UNITED STATES OF AMERICA
NUCLEAR REGULATORY COMMISSION

| CROW BUTTE RESOURCES, Inc. |) | Docket No. 40-8943 |
| (License Renewal for the In Situ |) | ASLBP No. 08-867-OLA-BD01 |

I have reviewed documents associated with the Renewal of the Source Material License (No. SUA-1534) for Crow Butte, Nebraska and have found the applicant has not provided sufficient data to demonstrate proper development of (1) baseline water quality in the aquifer exemption zone and (2) excursion limits at monitoring wells.

Figure 1. Chart of aquifer exempt zone (i.e., zone surrounded by monitoring wells) and locations for baseline wells established with valid statistical methods.

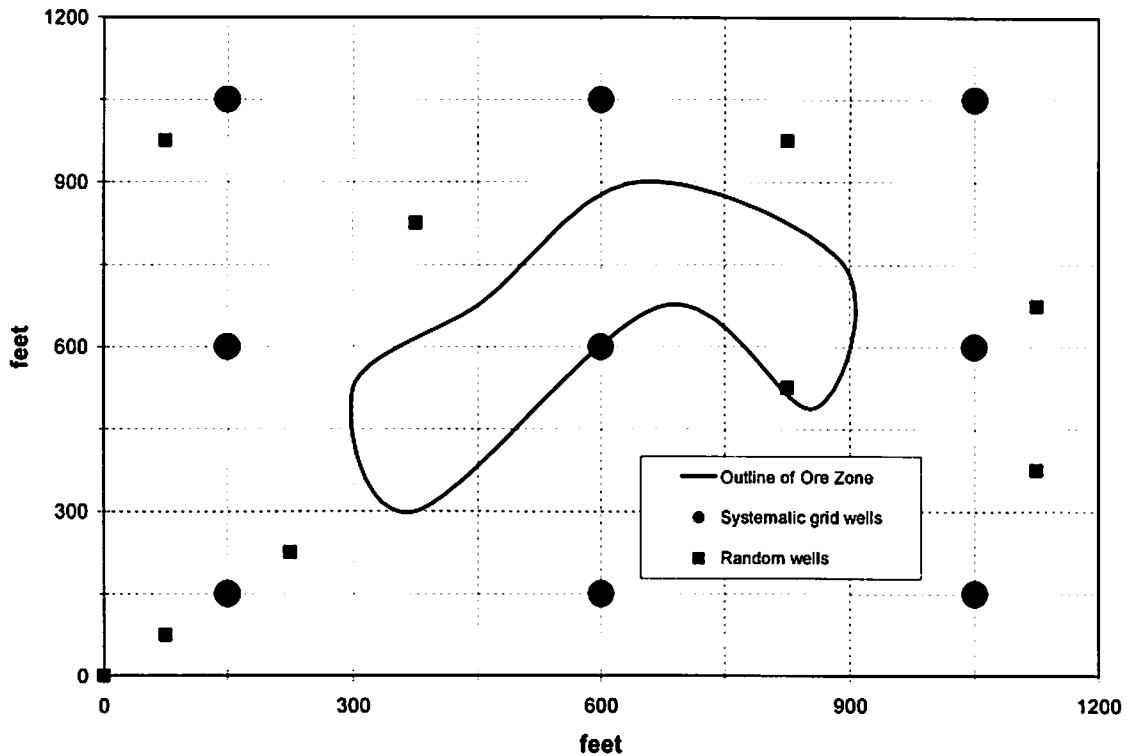
Figure 2.9-2 illustrates the proposed aquifer exemption zone around the ore bodies, and there is no statistical justification for the location of the baseline wells to validate that the results in Table 2.9-4 represent the water quality in the exempt zone. Note that the baseline wells in Figure 2.9-2 are clustered and not spread out over the entire exempt zone, and this violates statistical protocol. Within the aquifer exemption zone (i.e., the zone within the monitoring well ring), a systematic grid must be laid out to determine the location of the baseline water-quality wells. The density of nodes within the grid will be determined by the size of the area and the data quality objectives. Data quality objectives (EPA 2000a & 2000b) state the statistical confidence one wishes to have in the estimate of the mean (normal or log normal distribution) or median (no defined distribution) for the water-quality parameters. If a high level of confidence is required for an estimate of the mean or median, more baseline wells will be required.

For example, if we wish to establish a 95 percent confidence interval on the mean for a normal or log normal set of data, with an estimated standard deviation of 20 and using a half width of 10 for the confidence interval, an exempt aquifer area measuring 1200 by 1200 feet would require a minimum of 9 baseline wells (PNNL, 2007). The location of the wells on the grid nodes is illustrated on Figure 1. The half width of the confidence level is a key consideration in determining the number of wells; as the half width decreases, the number of wells increases. The selected level of confidence and estimated standard deviation also affect the number of wells. A lower level of confidence and lower estimate of the standard deviation would result in fewer baseline wells. Alternatively, we may elect to locate wells on the grid using a random number generator. In general, less wells are required if they are located randomly, and this is shown on

Figure 1 as two random locations per quadrant. Free modeling software, developed by the Pacific Northwest National Laboratory for the Department of Energy (PNNL 2007), allows a large number of scenarios to be evaluated to determine the optimum data quality objectives and sampling approach for the stakeholders.

Figure 2. Cross section of an aquifer (20 to 90 feet) showing improper (Well 1) and proper (Well 2) sampling intervals to obtain a representative sample.

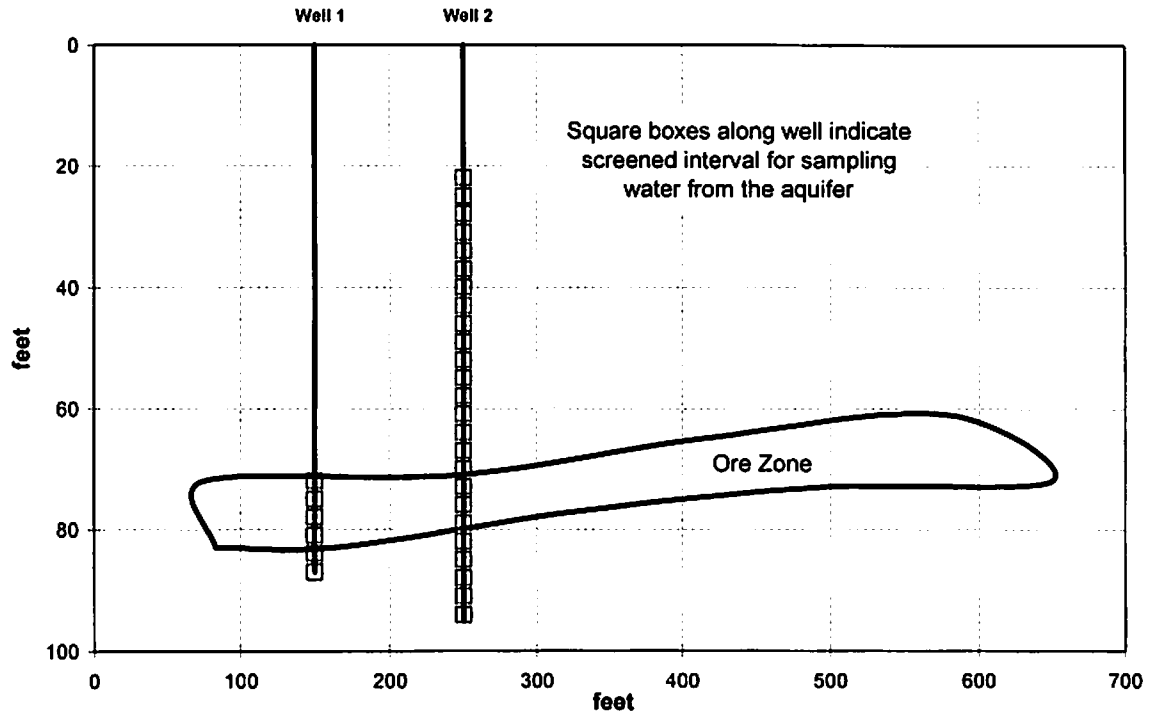
The well logs provided indicate the Chadron is approximately 50 to 80 feet thick through most of the mining area (Figures 2.6-4 through 2.6-11). The sampling interval for the baseline wells is 20 feet (Table 2.9-3), which does not represent the entire thickness of the aquifer. Figure 2 shows that a water sample obtained from Well 1, screened only in the ore zone, returns a biased sample that does not represent the water quality of the column of water at the given location. Well 2 (Figure 2) indicates the correct method for sampling the water, which requires that the entire thickness of the aquifer be screened to obtain a representative sample.

- 6) Figures 2.6-4 through 2.6-11 show the thickness of the Chadron to be 40 to 80-foot thick through most of the mine area. Therefore, it is inappropriate to use a screened interval of 20 feet to sample the groundwater from the ore zone (Table 2.9-3). The entire thickness of the aquifer must be sampled to obtain a representative sample.

Figure 3. Probability plot indicating that all data do not lie near or on a straight line, which rules out a normal or log normal distribution.

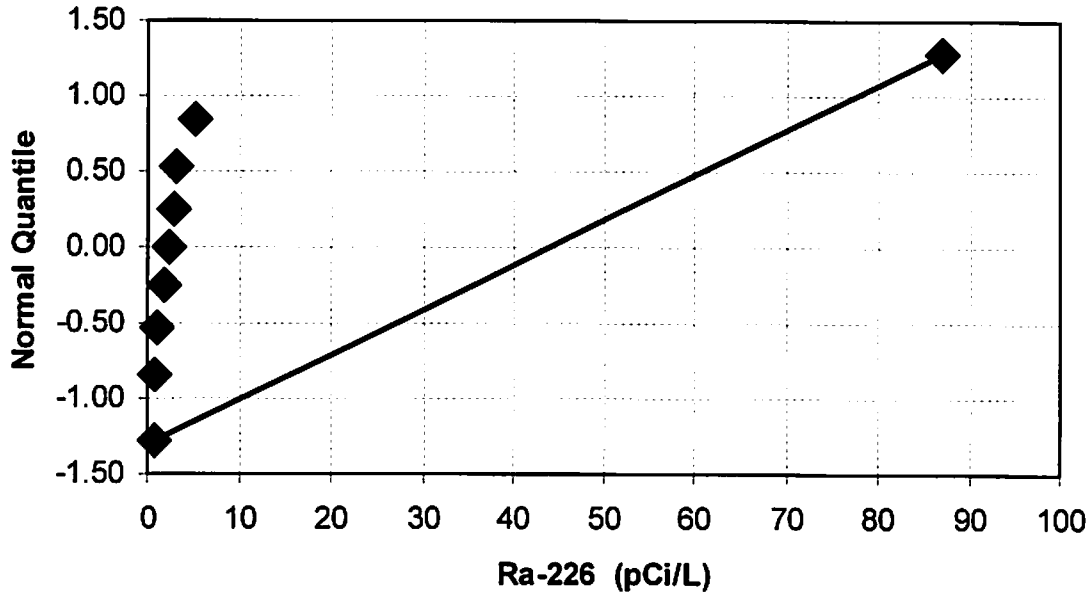
A probability plot of the data (Figure 3) and the results of the Shapiro-Wilk test confirm this. The normal-quantile values must fall on a straight line or the Shapiro-Wilk probability values must exceed 0.05 (at the 95 percent confidence level) for a normal or log normal distribution to be declared, which is clearly not the case. Therefore, the median, and not the mean, must be used to represent the central tendency of the data. Note that inappropriate use of the mean results in a high bias on the estimate of the baseline value for radium-226, which improperly elevates restoration clean-up levels and lowers the costs associated with the number of pore volumes needed to exchange to meet the clean-up levels.

Figure 4. Proper use of a control chart to determine lixiviant excursions.

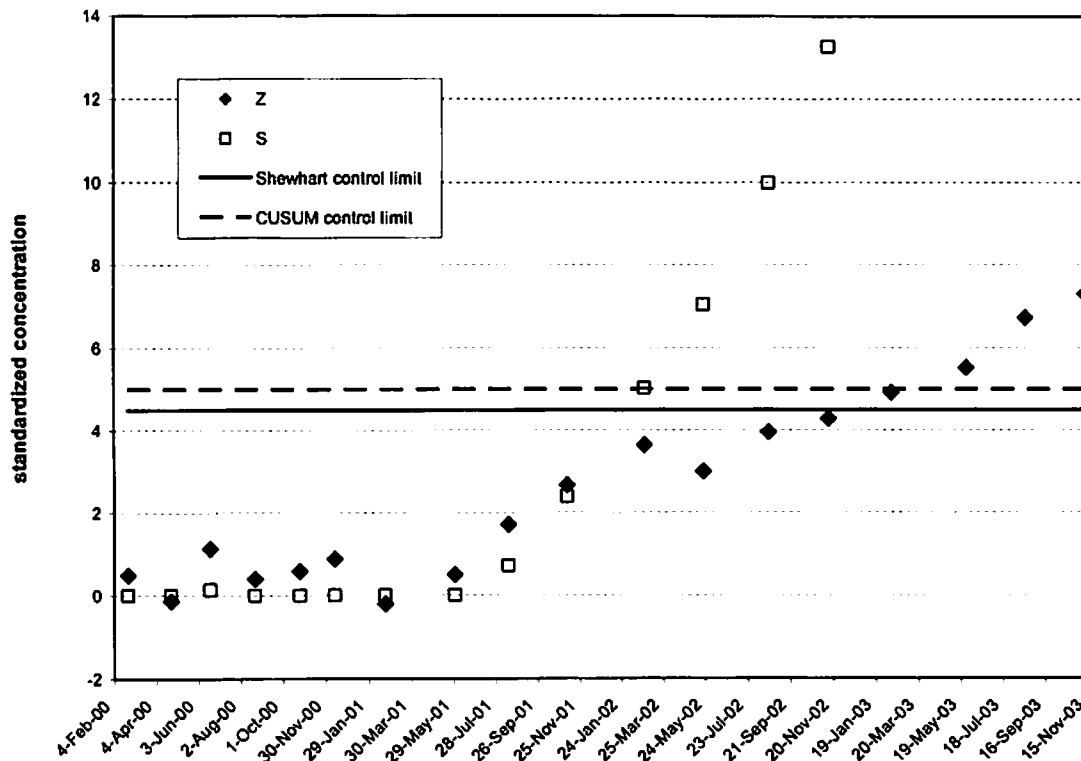
Figure 4 illustrates the importance of using the SCL and CUSUM for monitoring lixiviant excursion. The SCL (Z) and CUSUM (C) are plotted for an excursion parameter, a gradual increase in contamination exceeds the CUSUM limit in February of 2002, while the SCL limit is not exceeded until January of 2003. The SCL limit is similar to the CBR's use of 5 standard deviations above the mean for any one sampling event, although EPA recommends 4.5 standard deviations for any one sampling event. Using only the SCL limit allows contamination to migrate beyond the monitoring well for nearly a year before an excursion is declared. Therefore, if the CUSUM is not used with the SCL limit a gradual increase in contamination will not be detected and migration of diluted lixiviant will pass the monitoring well without corrective action.
